January 09, 2001  
RC-01-0010

Subject: VIRGIL C. SUMMER NUCLEAR STATION  
DOCKET NO. 50/395  
OPERATING LICENSE NO. NPF-12  
RESPONSE TO QUESTIONS DATED  
DECEMBER 28, 2000  
MSP 00-0244

Response to NRC questions received December 28, 2000

## Stress Intensity Factor Plots

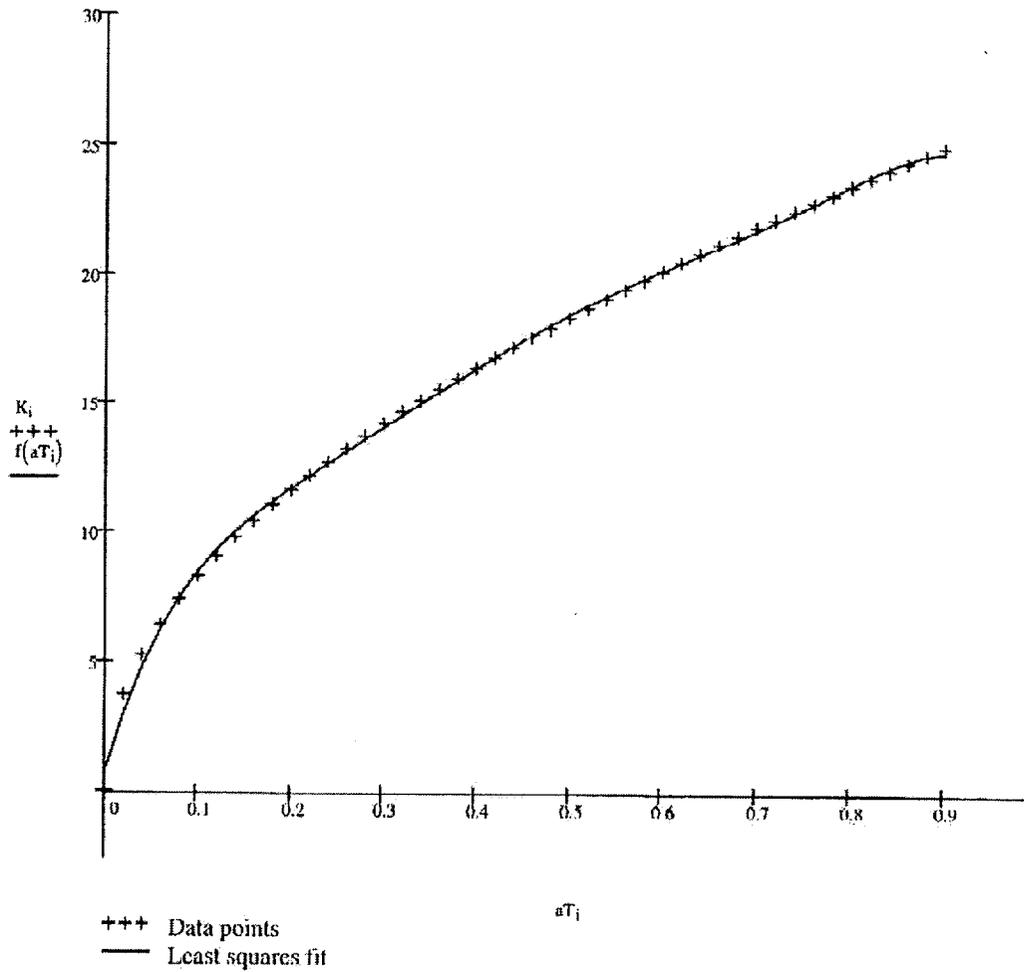
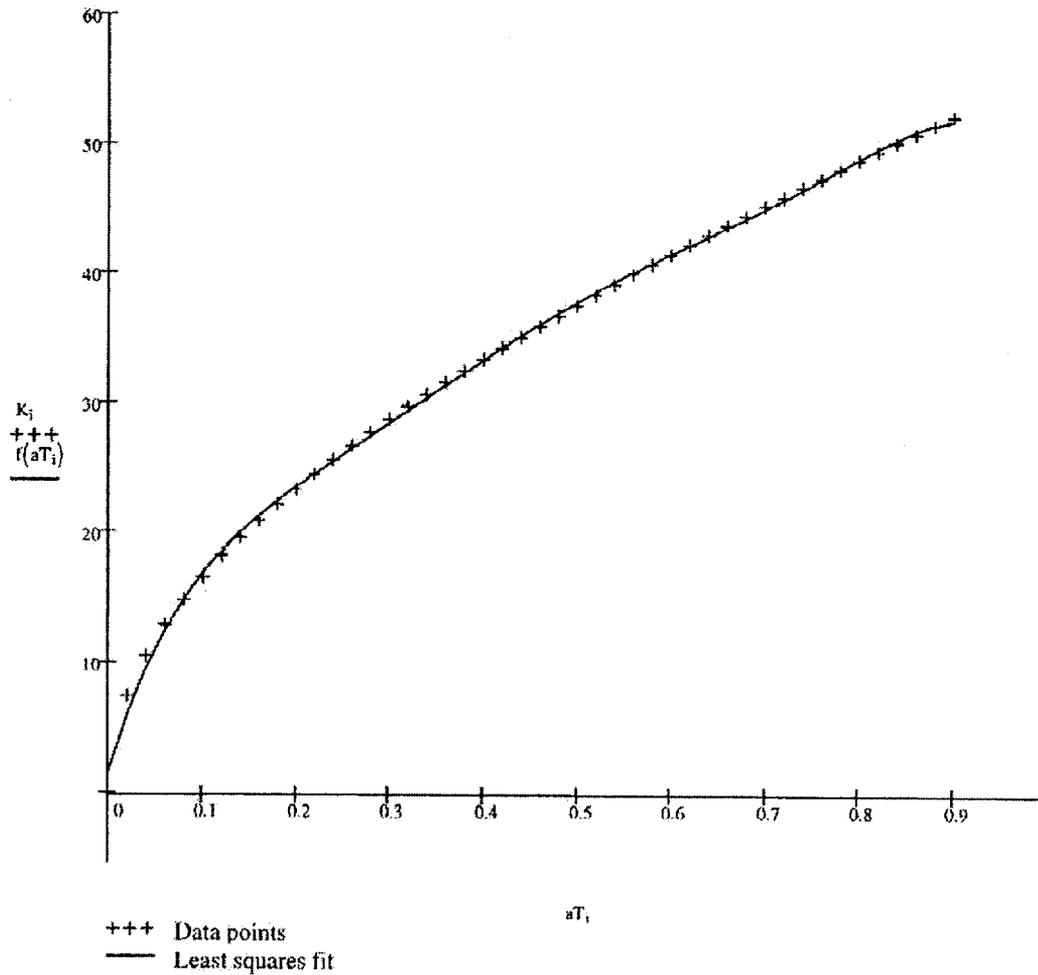
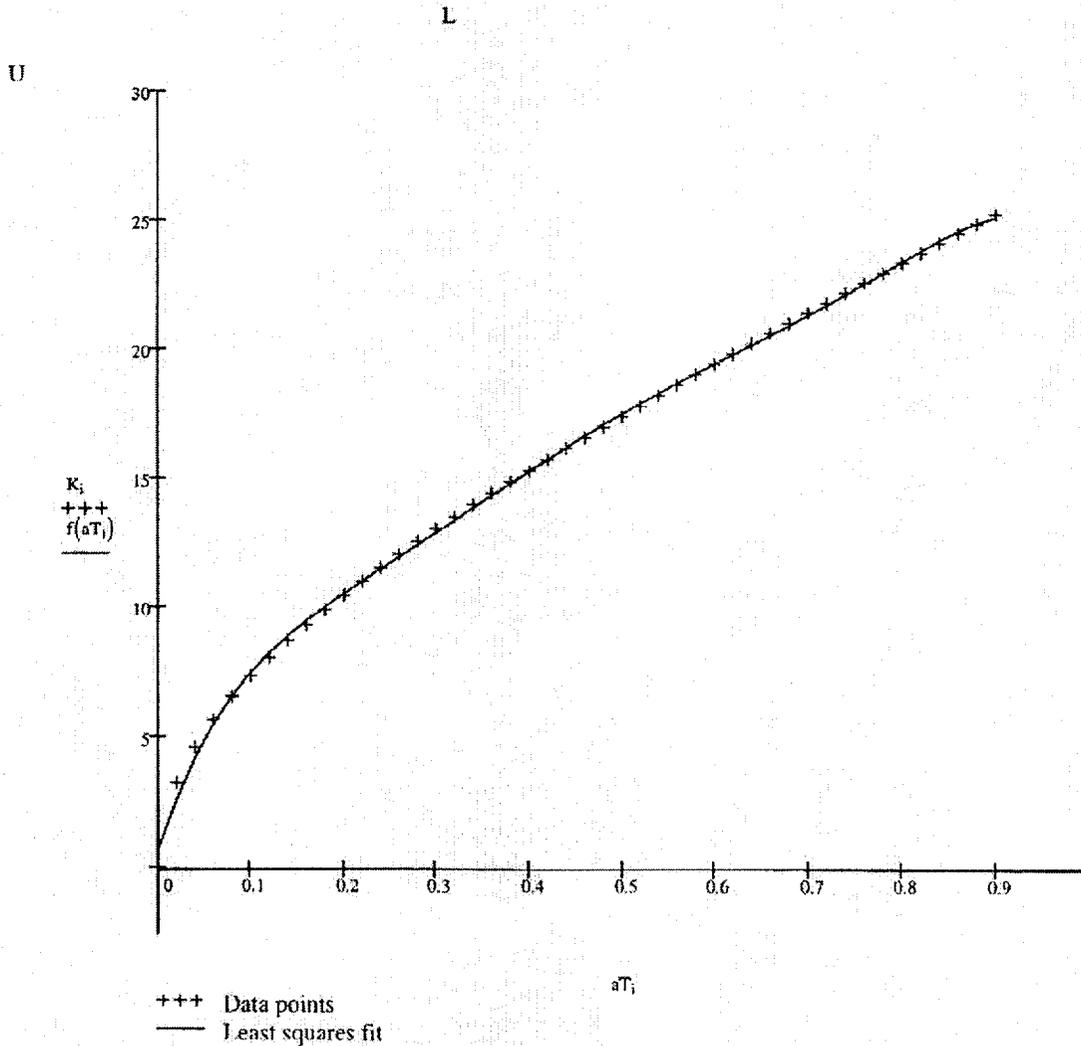
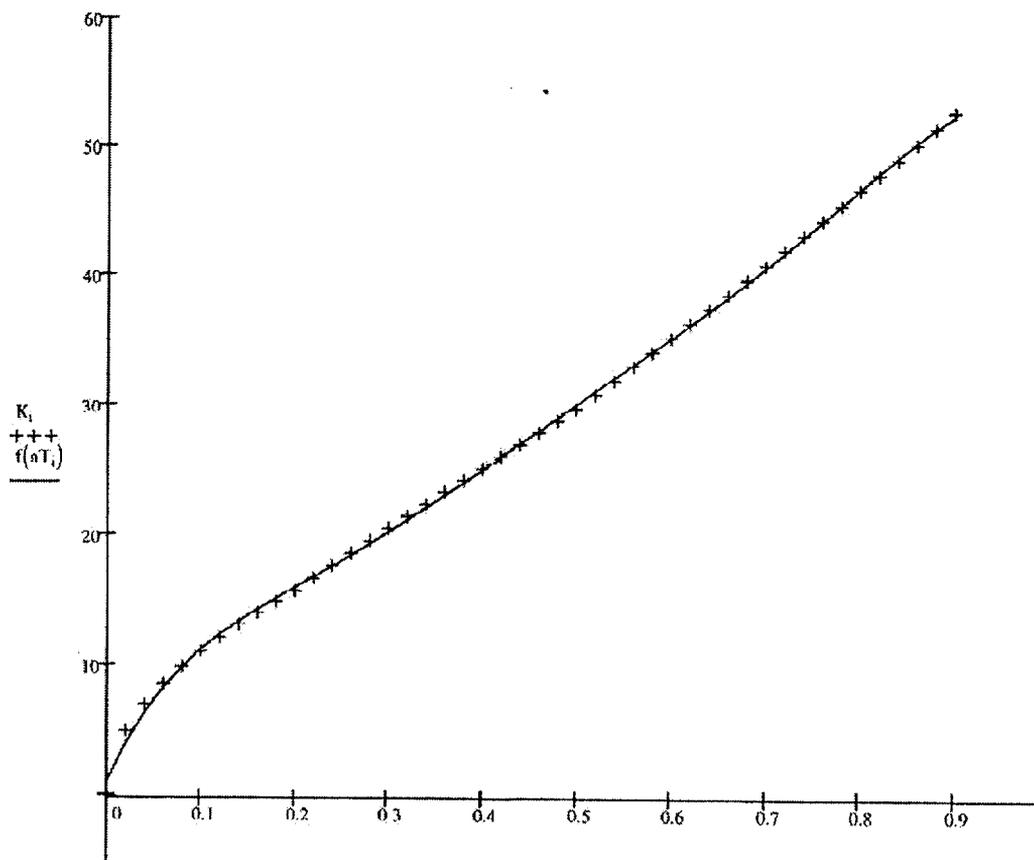
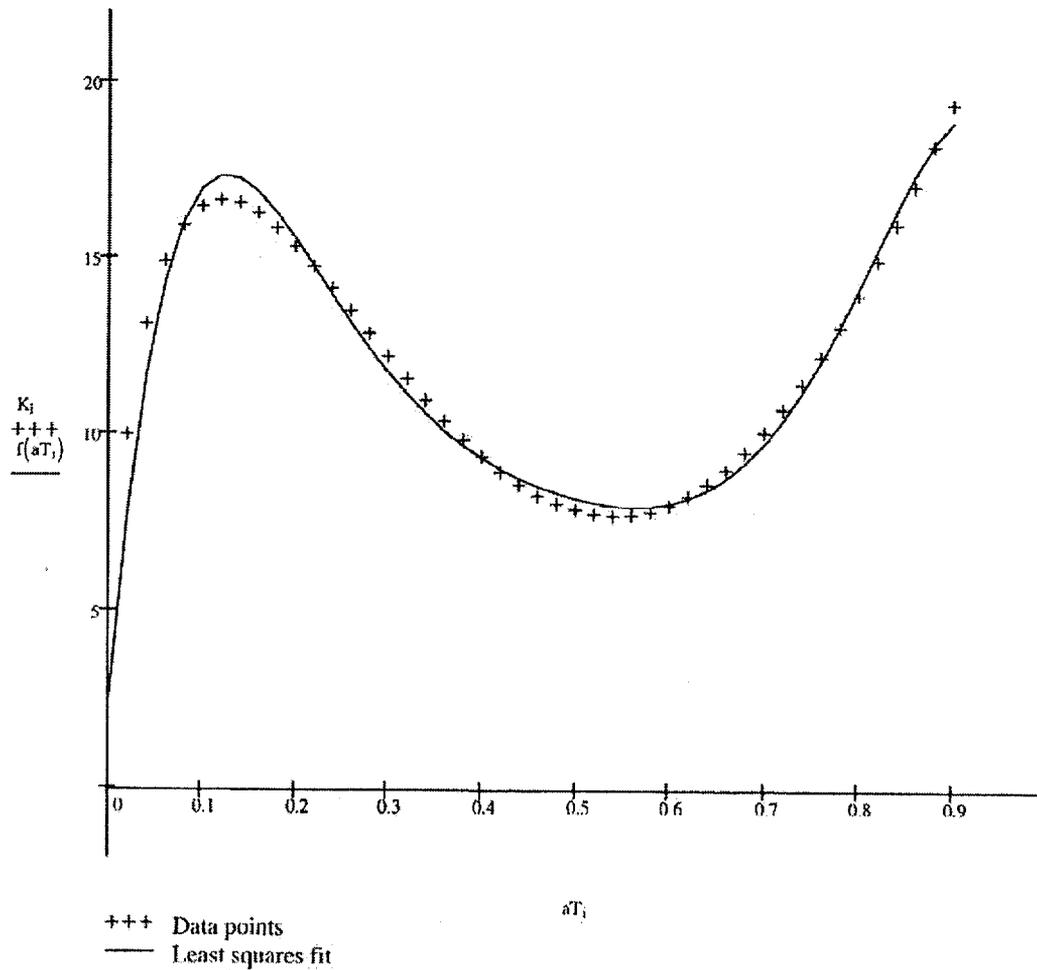
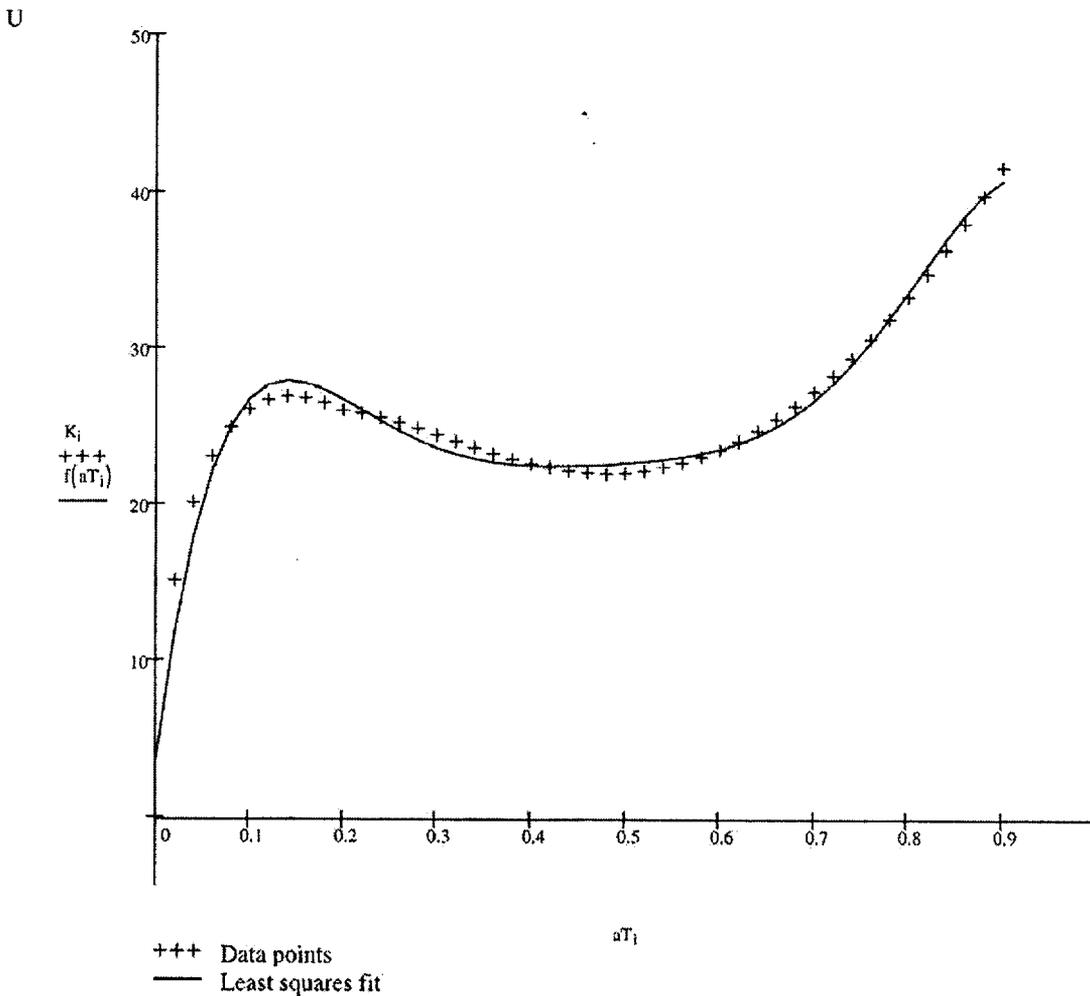
2. In making check calculations, we find that the stress intensity factor expressions in Appendix H of Section XI are about 20% more conservative than those of Appendix A. Please explain the difference, and the justification for your stress intensity factor calculations.

Response

The stress intensity factor expressions in Appendix H were developed and put in the Code in the mid to late 1980's, and were based on expressions available at that time. The expressions in Appendix A are based on the latest available expressions, which are more accurate. We have used an expression even more accurate than the expressions in Section XI, Appendix A, and that is the Raju-Newman expression for flawed cylinders. The stress intensity factor results for several cases are attached for your information, in six different plots.
